MIL-PRF-83536/24
AMENDMENT 3
10 July 1999
AMENDMENT 2
30 September 1996

PERFORMANCE SPECIFICATION SHEET

RELAYS, ELECTROMAGNETIC, ESTABLISHED RELIABILITY, 3PDT,
LOW LEVEL TO 10 AMPERES, PERMANENT MAGNET DRIVE, MAGNETIC LATCH,
HERMETICALLY SEALED, ALL WELDED, TRANSIENT SUPPRESSED DC COIL

CIRCUIT DIAGRAM
(ALTERNATE INTERNAL
DIODE CONFIGURATION)

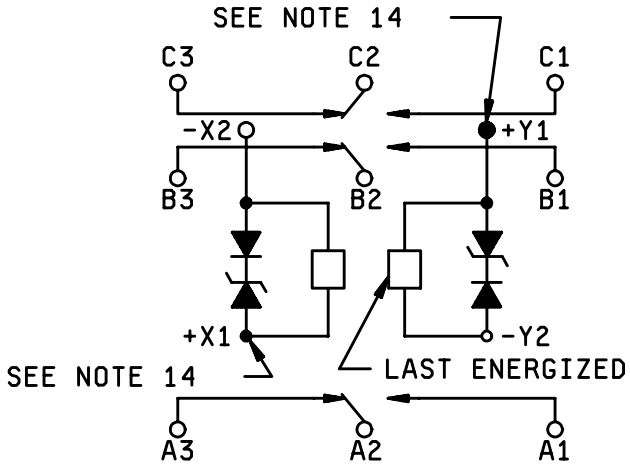
FIGURE 1, add the following circuit diagram:
